City of Akron

Akron Water Pollution Control Station No Feasible Alternative (NFA)

Addendum No. 1 Update with Supplement

November 25, 2009

CITY OF AKRON
WATER POLLUTION CONTROL STATION
VIABILITY OF CONTRACT
STABILIZATION ALTERNATIVES
EXHIBIT 3 - PHASE 1
MODIFICATIONS FOR 130 MGD CAPACITY

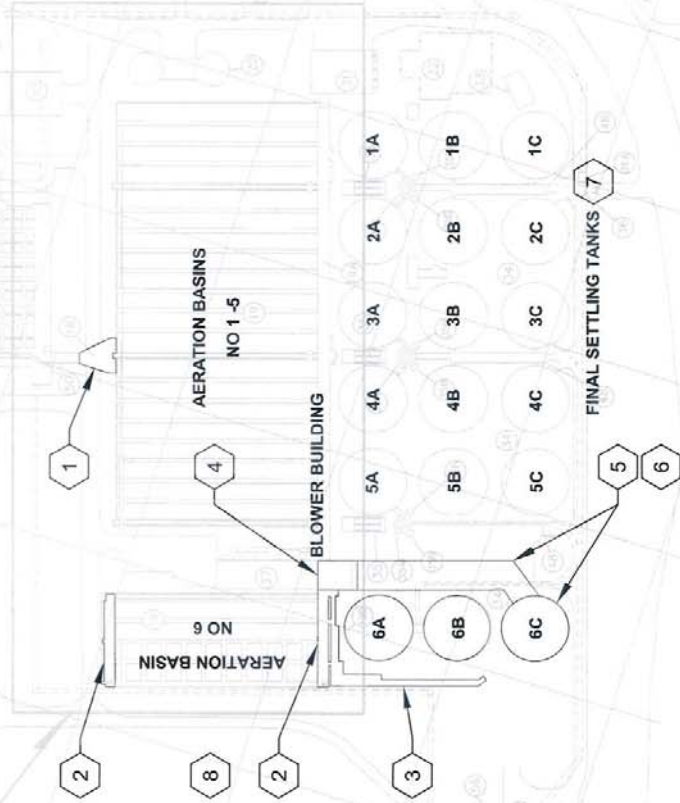
1. REMOVE ASSOCIATED MORNING GLORIES FEEDING NORTH CHANNEL AERATION BASINS NOS. 5 AND 6.
2. MODIFY INLET CHANNEL TO AERATION BASIN NO. 6.
3. MODIFY MLSS CHANNEL TO FINAL SETTLING TANK (FST) NOS. 6A, 6B AND 6C.
4. INSTALL NEW BLOWER AND (3) NEW RAS PUMPS FOR TRAIN 6.
5. INSTALL NEW RAS LINE FROM FST NO. 6C TO RAS WET WELL.
6. REMOVE EXISTING WEIRS AND BAFFLES AND PROVIDE NEW WEIRS ON FST NOS. 6A, 6B AND 6C. PROVIDE ALGAE SWEEPING SYSTEM ON FST NOS. 6A, 6B, AND 6C.
7. REMOVE DOMES ON ALL FST'S (18 TOTAL).
8. INSTALL INSTRUMENTATION FOR TESTING AND EVALUATING STORM MODE FOR TRAIN 6.

CITY OF AKRON
 WATER POLLUTION CONTROL STATION
 VIABILITY OF CONTRACT
 STABILIZATION ALTERNATIVES
 EXHIBIT 4 - PHASE 2
 MODIFICATIONS FOR 170 MGD OR
 GREATER CAPACITY

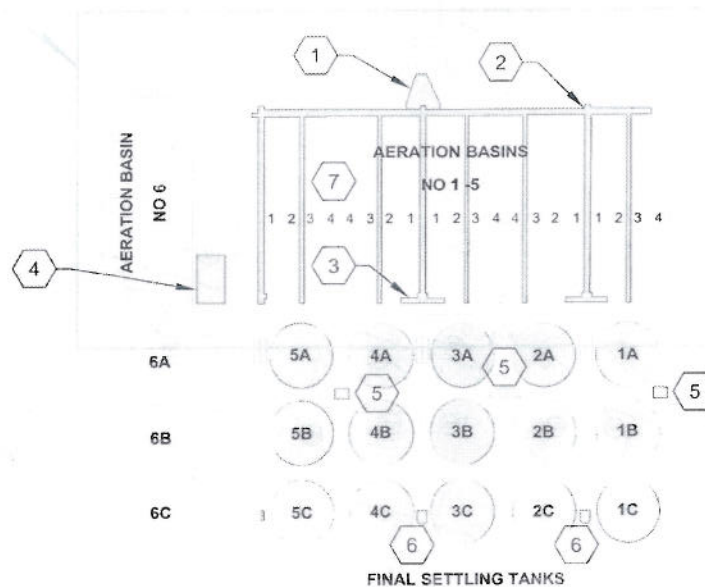
1. REMOVE HYDRAULIC RESTRICTIONS AT AERATION BASIN SPLITTER.
2. MODIFY INLET CHANNELS TO AERATION BASINS NOS. 1-5.
3. CONSTRUCT NEW INLET CHANNELS FOR PASSES 1-4 ON AERATION BASIN NOS. 1-5.
4. REPLACE BLOWERS.
5. MODIFY JUNCTION BOXES THAT FEED FINAL SETTLING TANK (FST) NOS. 1-5 (A, B, & C).
6. REMOVE HYDRAULIC RESTRICTIONS ON ALL FST EFFLUENT STRUCTURES.
7. INSTALL INSTRUMENTATION FOR TESTING AND EVALUATING STORM MODE FOR AERATION BASINS NOS. 1-5.
